Service Bulletin

Subject	Change from the first mass production
Model	TASKalfa5550ci, TASKalfa4550ci, TASKalfa3550ci, TASKalfa3050ci

Since the first mass production, the following parts have been changed/added/deleted. And, the parts name of the fuser unit is changed from "FK-100/200" to "FK-8506/8507" since the 1st shipment. Please refer to page 4 for the change of the parts name.

Subject	Change of the primary feed unit (feed roller, retard roller, pickup roller)
Model	TASKalfa5550ci, TASKalfa4550ci, PF-730, PF-740

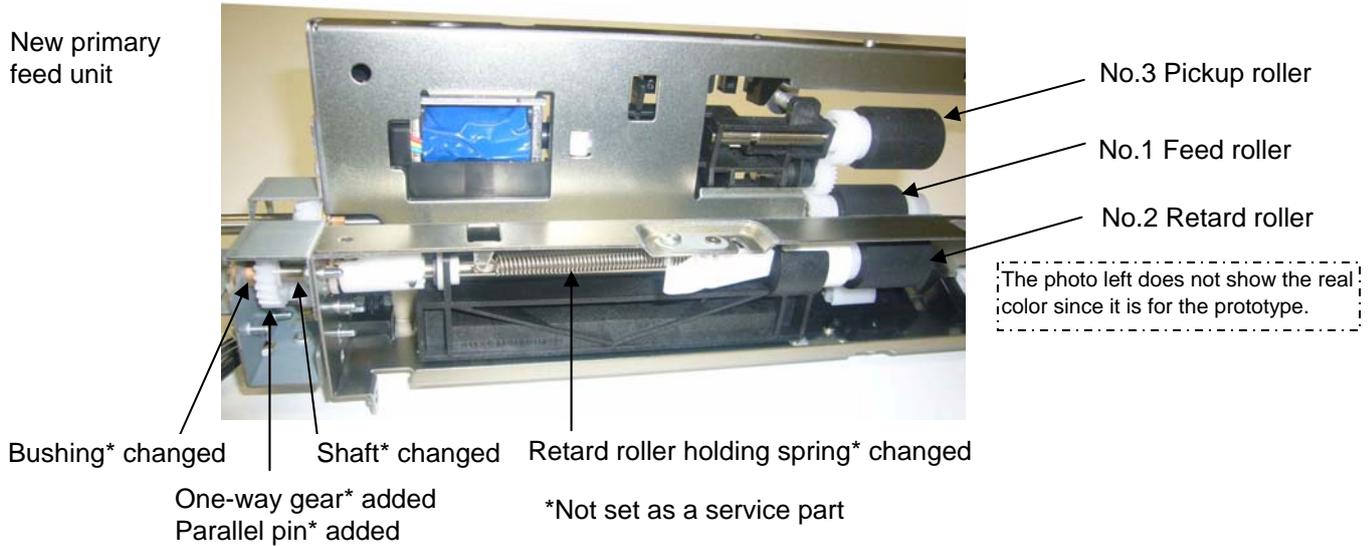
For common use of the feed, retard and pickup rollers for the primary feed unit with the series models, material of their rubber part is changed. According to this change, neighboring parts are also changed and please note attention is required when replacing the parts.

- Please note the following when replacing the pulleys in the primary feed unit.
 - The new rollers : can be used in either the old or new type primary feed unit (use the set of all the old or new parts)
 - The old rollers : can be used in the old type primary feed unit only.
 (Multi-ply feed jam may occur. (J051*) when using the them in the new type primary feed unit.
- *The old type parts (No.2,3) are not supplied. Use the new type roller set (No.4) when replacing the parts.
- The primary feed units are compatible and can be replaced without problem.
- Please distinguish the old and new rollers with color of the rubber part and collars.

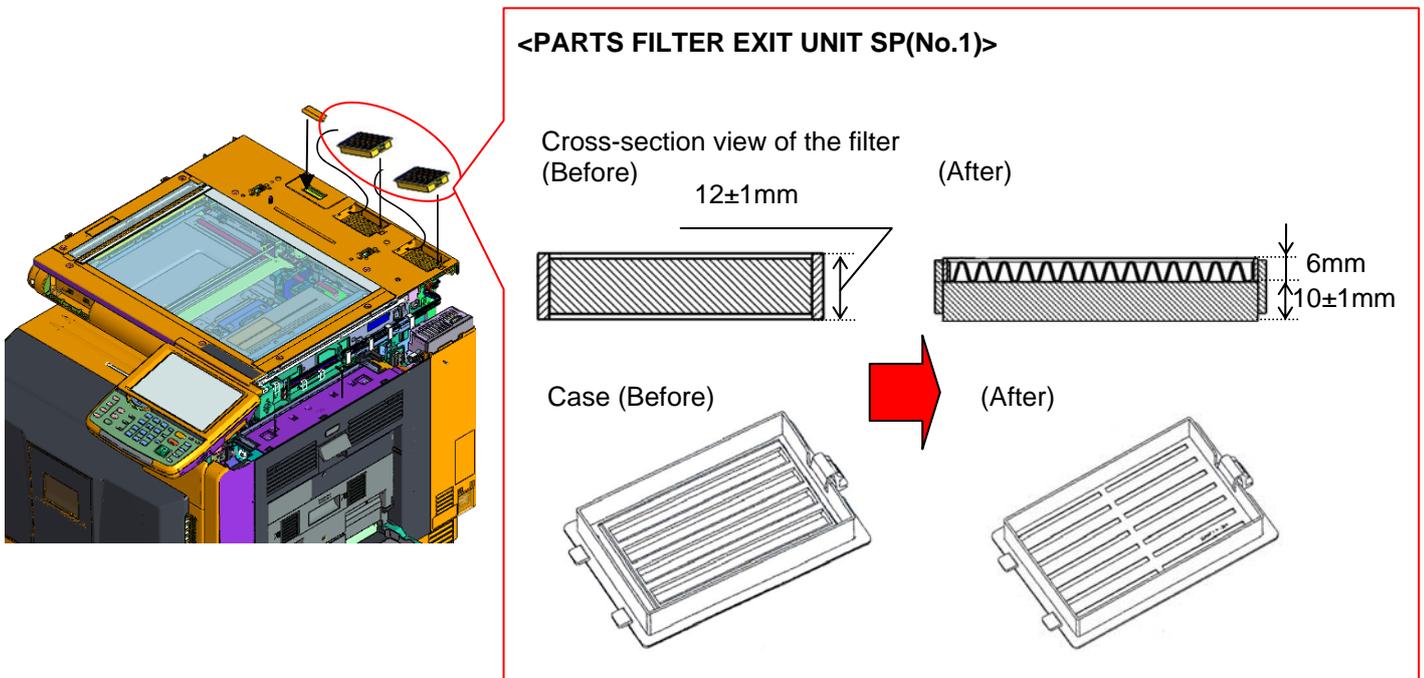
The shape of the filter and case at the eject section is changed as shown below in order to prevent the original from shifting because of the air-flow exhausted from the machine when scanning the thin original like news papers and leaflets on the contact glass. Accordingly, the filter as an individual part contained in the MK kit (MK-8505C/8305C) is changed to the assembly of the filter and case.

<Corrective measures> (production measures)

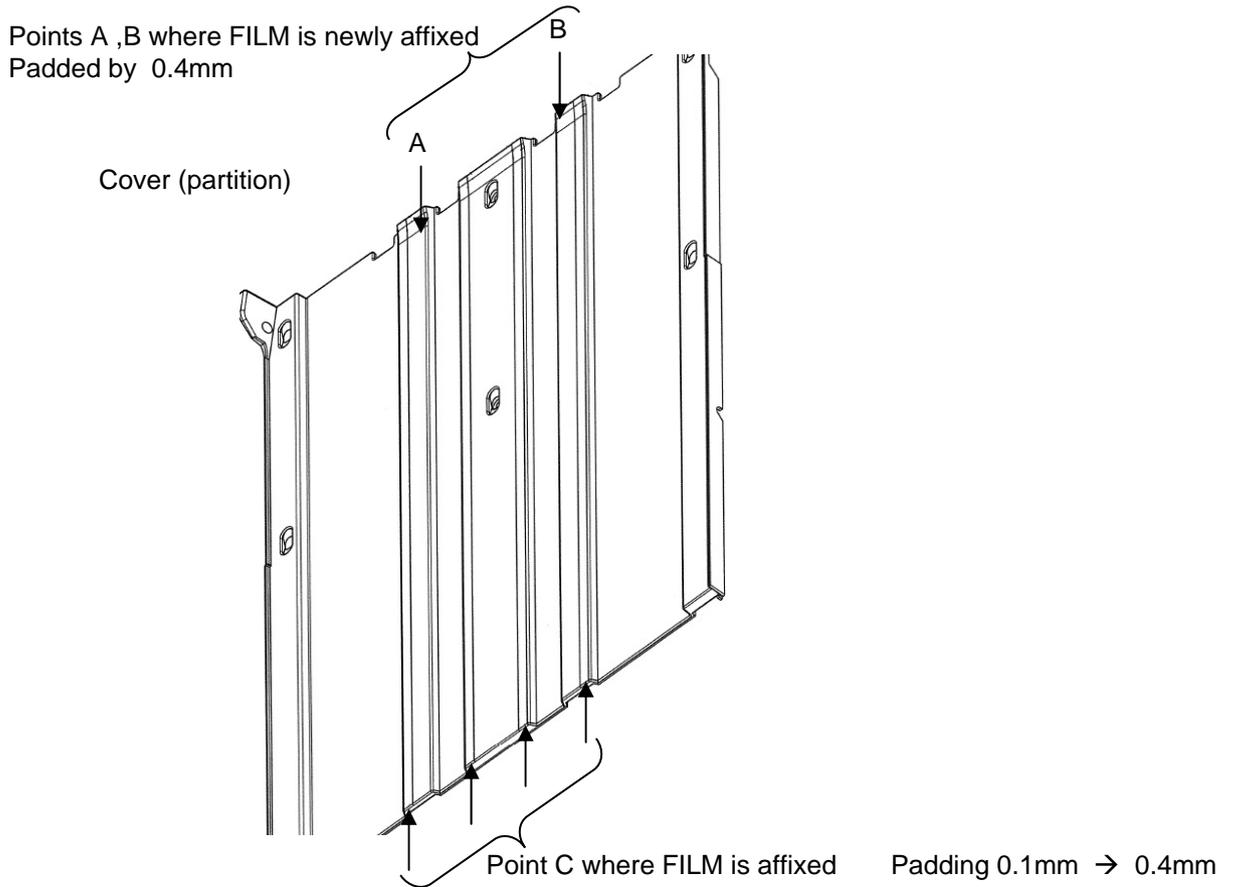
- The point C on the cover (partition) is partly padded where FILM PARTITION is currently affixed.
 - padding height 0.1mm → 0.4mm (4 points)
- Padding same as the point C is applied to the point A and B where FILM PARTITION is newly affixed.
 - padded by 0.4mm (2 points)
- FILM PARTITION is additionally affixed to the point A and B. (FILM PARTITION: total 4 pcs. → 6 pcs.)

<Content of changes>

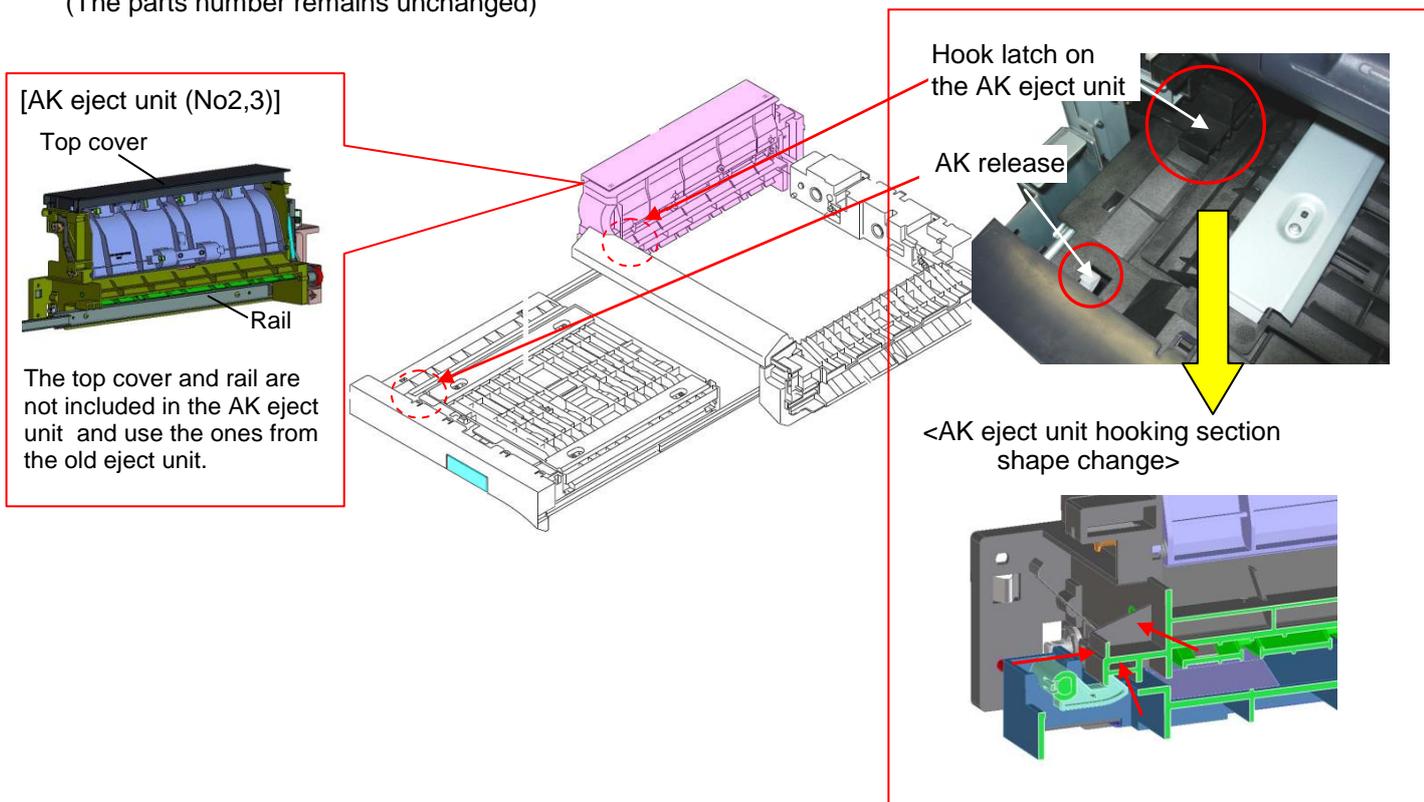
- 1) The shape of the handle is changed to improve the operation of the AK withdrawal. This is for the change of the way to pulling out the AK from pulling out the handle laterally (as in the figure **A** in the Table 1) to pulling it out after once pulling it up (as in the figure **B** in the Table 1).
- 2) The handle that is not for field supply is changed to the service parts after the above change. The AK eject unit for the TASKalfa 7550ci/6550ci/8000i/6500i is changed to the service parts as No3 while the AK-730 eject unit is set up for the service parts as No2. (The handle is not changed since it is mechanically incompatible between the one for the TASKalfa 7550ci/6550ci/8000i/6500i and for AK-730)
- 3) The shape of the AK eject unit hooking section is changed to reinforcing it.
(The parts number remains unchanged)

[Where changed]

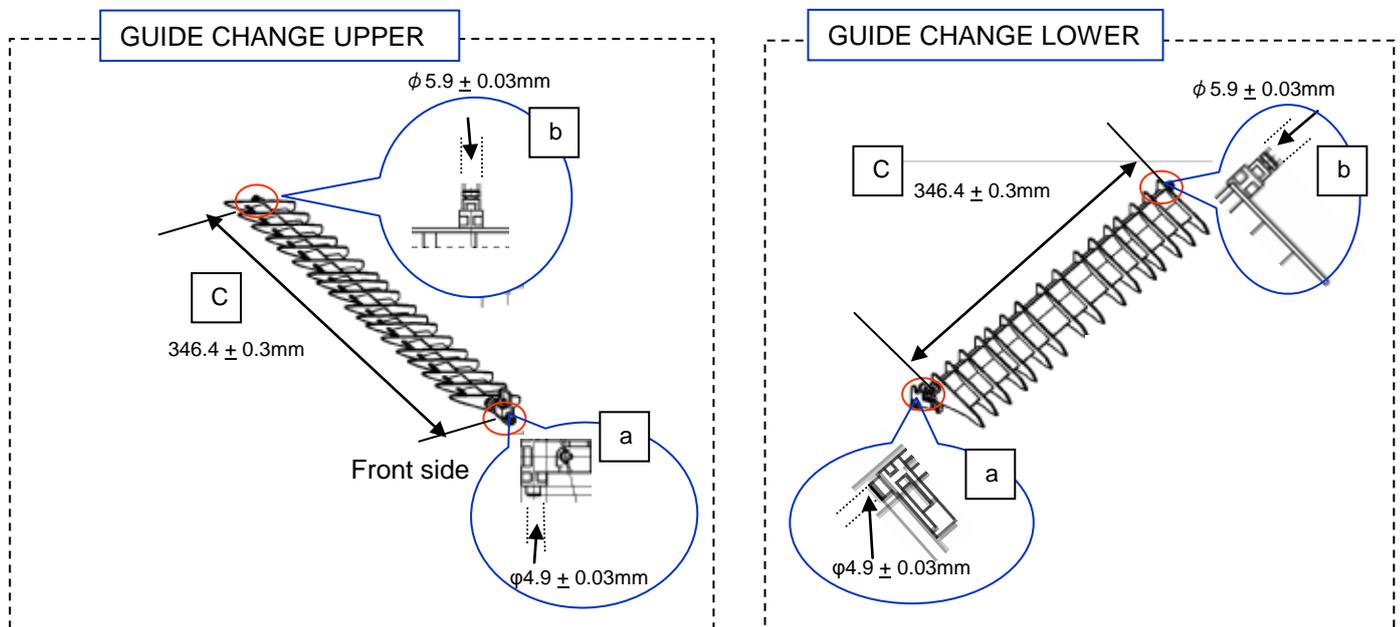
GUIDE CHANGE UPPER / GUIDE CHANGE LOWER : shaft diameter and length changed

<Content of change>

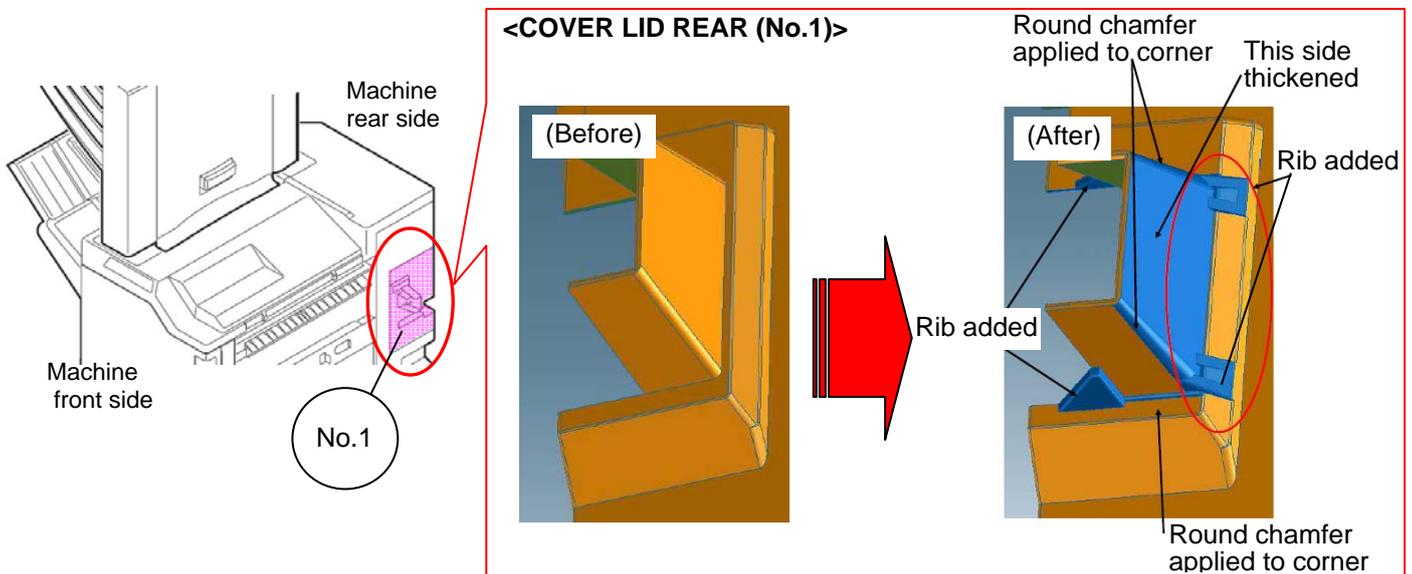
The shape of COVER LID REAR(No.1) is changed for strengthening it.

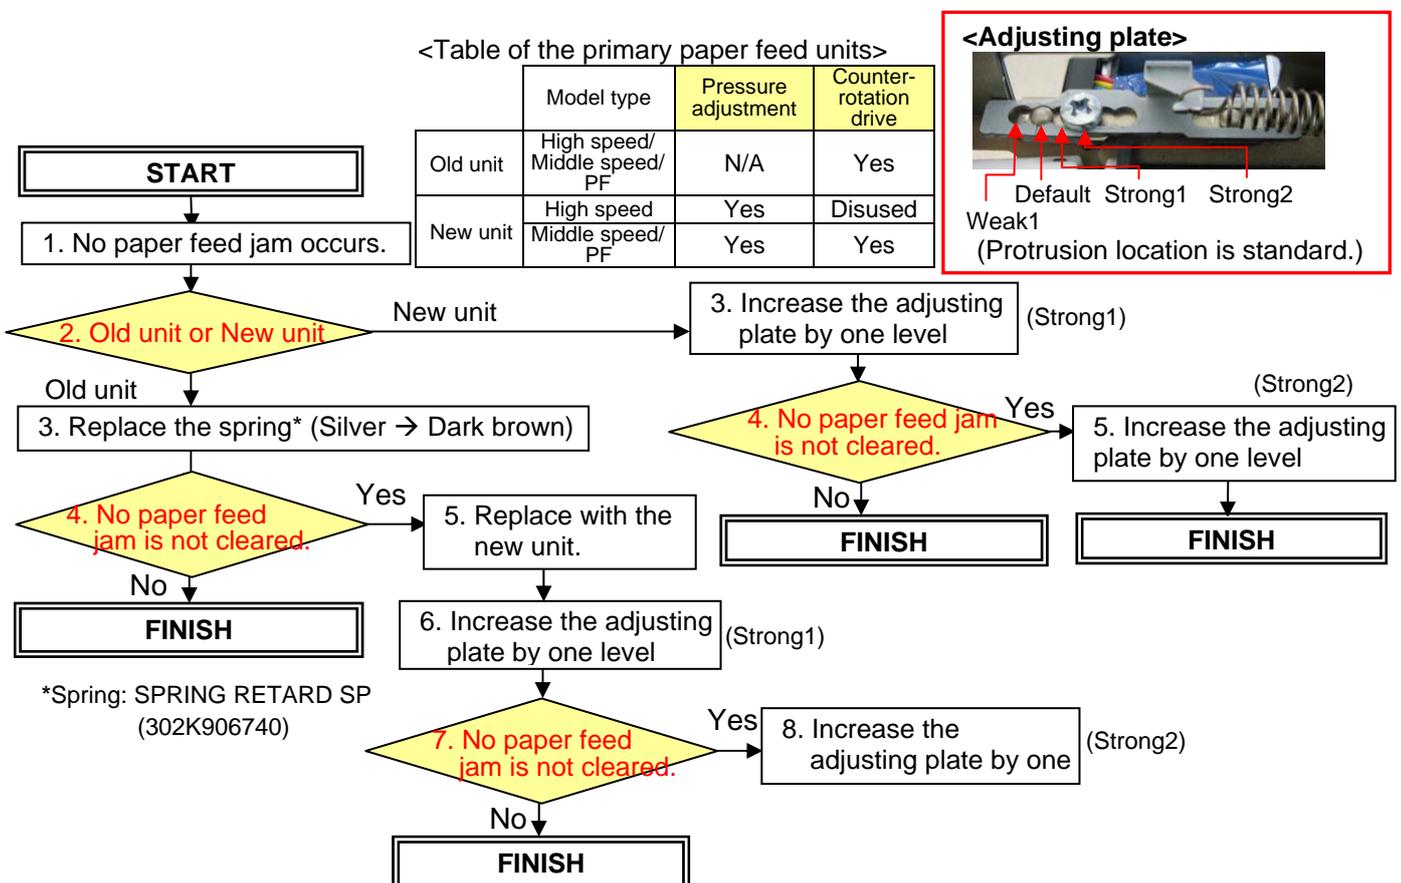
The primary paper feed unit is changed as below.

<Changed section at the actuator switch>

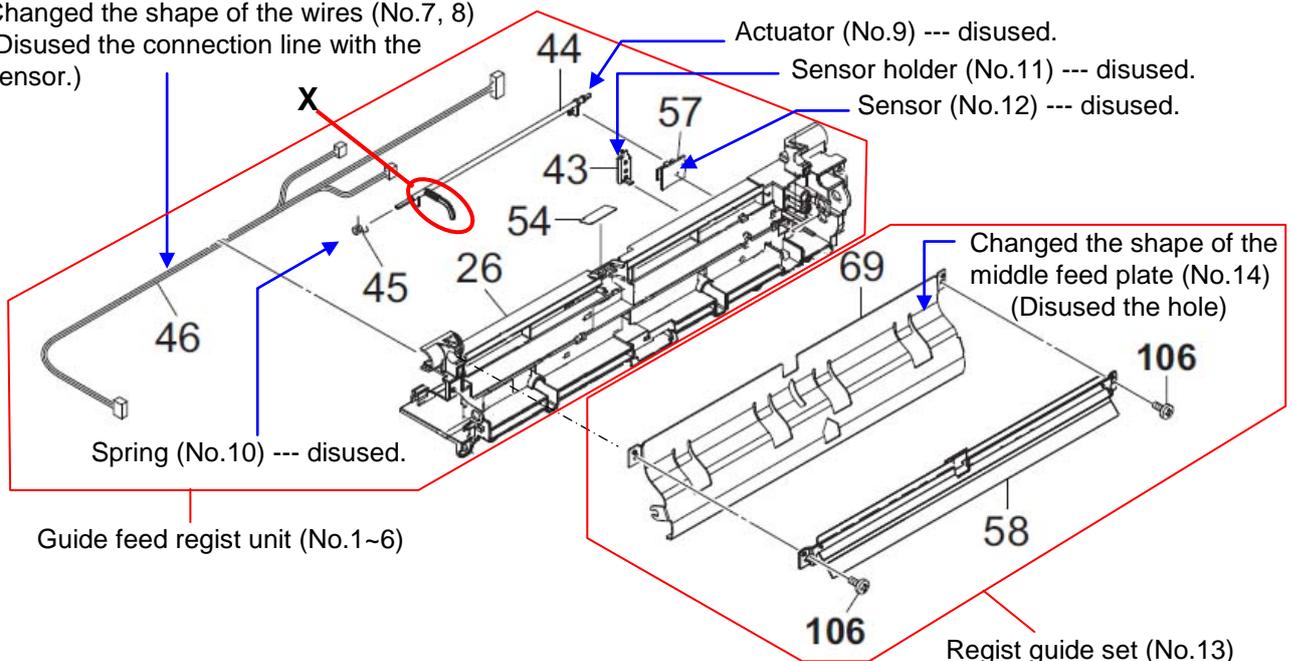
Changed the shape of the wires (No.7, 8)
(Disused the connection line with the sensor.)

<New drum drive unit>

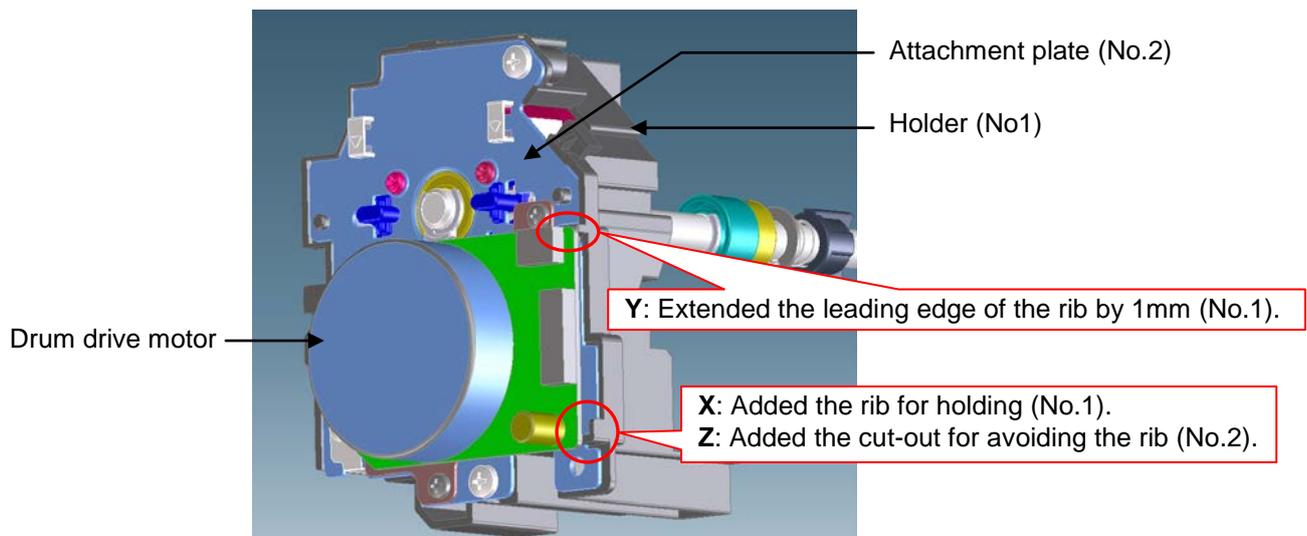
- The holder (No.1) of the drum drive unit is changed as below in order to strengthen the holding of the drum drive motor board.
 - The rib for holding (X in the figure below) is added.
 - The leading edge of the rib (Y) is extended by 1mm.
- Accordingly, the cut-out (Z) is added to the attachment plate (No.2) for avoiding the contact with the rib (X).

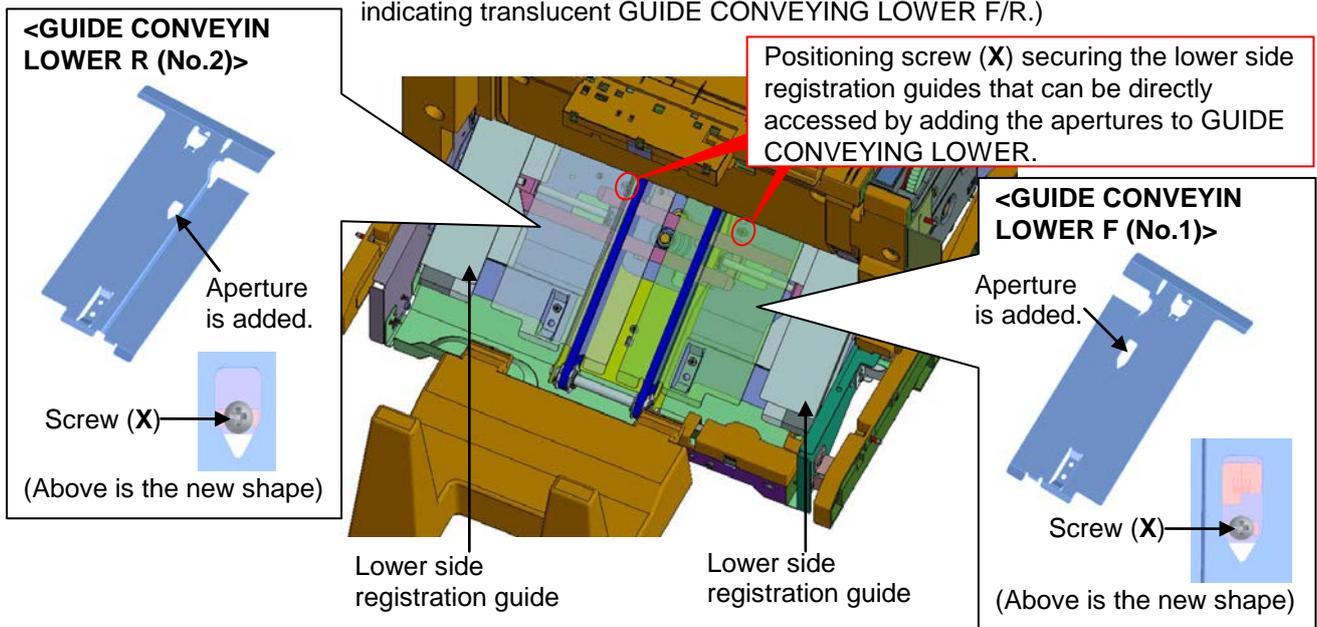
Currently, GUIDE CONVEYING LOWER (No.1, 2) needs to be removed for loosening the positioning screw (X) securing the lower side registration guide when adjusting. At this time, its work becomes unnecessary by adding the apertures to GUIDE CONVEYING LOWER (No.1, 2) in order to directly access the screw.

<Content of changes>

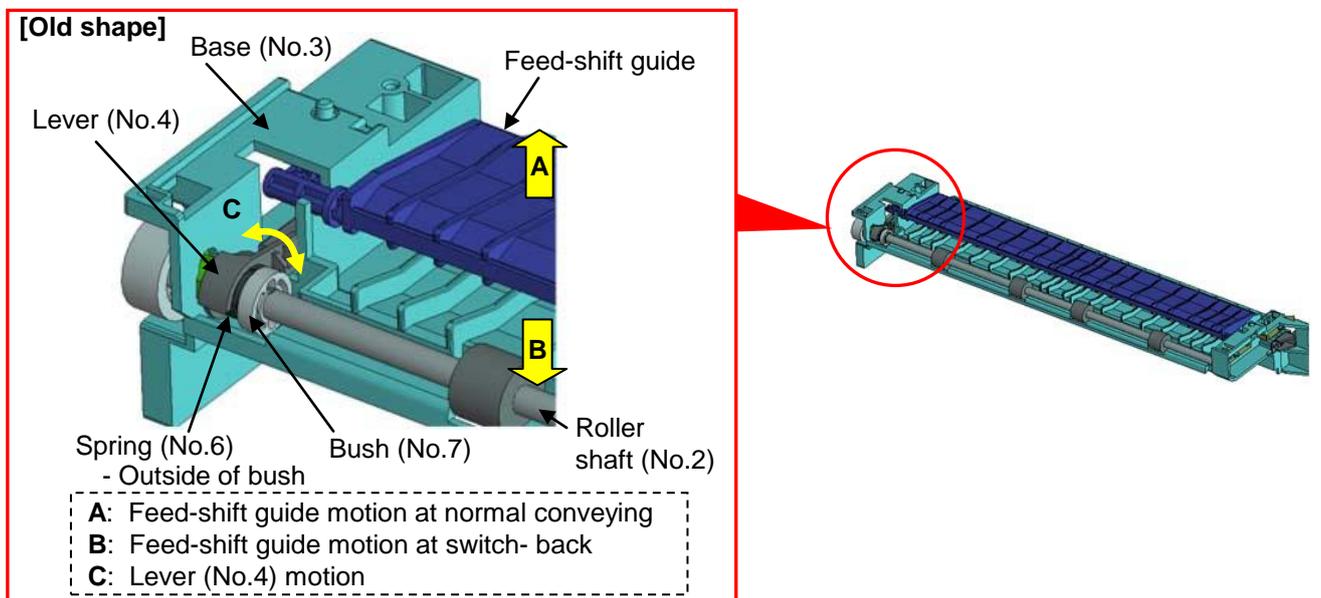
- 1) The simple torque limiter (of spring (No.6) and bush (No.7) type) is changed to the standard torque limiter (No.5).
- 2) According to the above change, the shape of the roller shaft (No.2), base (No.3) and lever (No.4) are changed.
- 3) PARTS CONVEYING ASSY SP (No.1) is set up as service parts for improving the serviceability in field.
